PRODUCT CHANGE NOTIFICATION

Bourns® EMS Non-Contacting Absolute Encoder Connector Change

Model EMS22A and EMS22Q Series

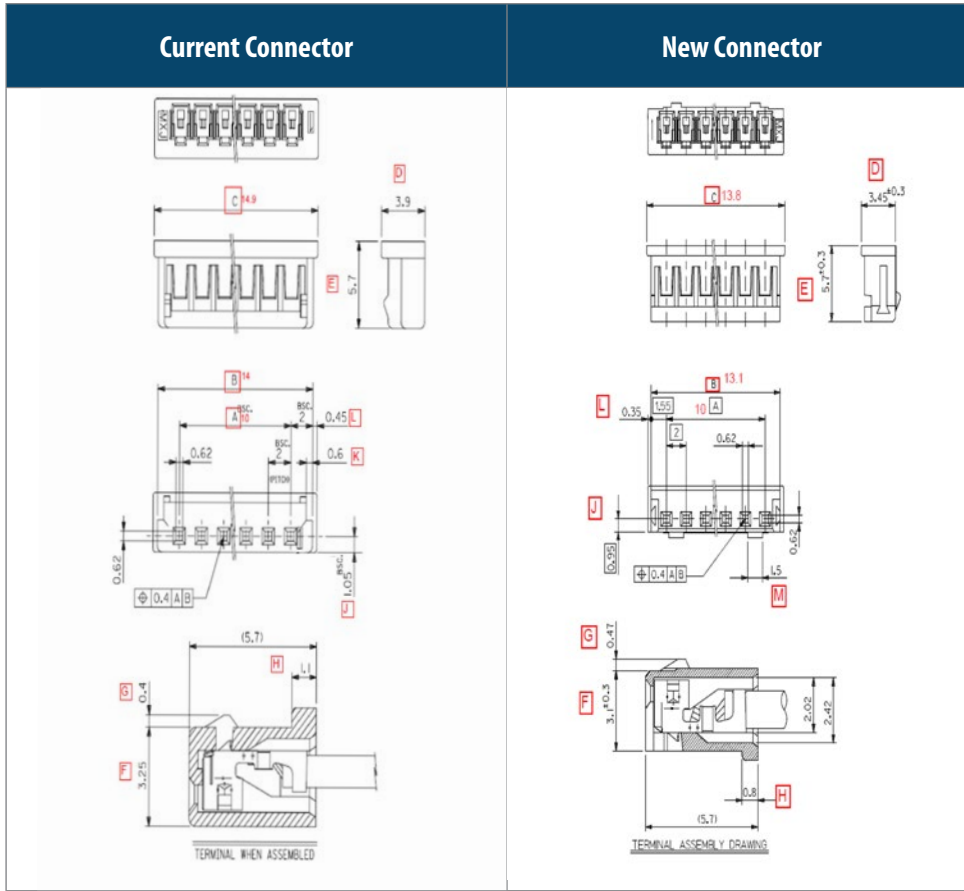
Riverside, California – May 26, 2020 – Effective **immediately September 1, 2020**, the connector used for the Bourns® Model [EMS22A](#) and [EMS22Q](#) series will be changed to the Molex 051065-0600. The current connector has been discontinued by the manufacturer. The dimensions of the Molex 051065-0600 are slightly different than the original connector but the replacement connector is made with comparable materials. The change in dimensions shown on the following page could impact the customer's application. Affected part numbers are listed below.

The change in dimensions will affect the form and fit of the product. This change will have no effect on the function, quality or reliability. Samples for evaluation are available upon request.

Note: For this replacement the mating connector must be changed to manufacturer series P/N: 53253 or P/N: 53254
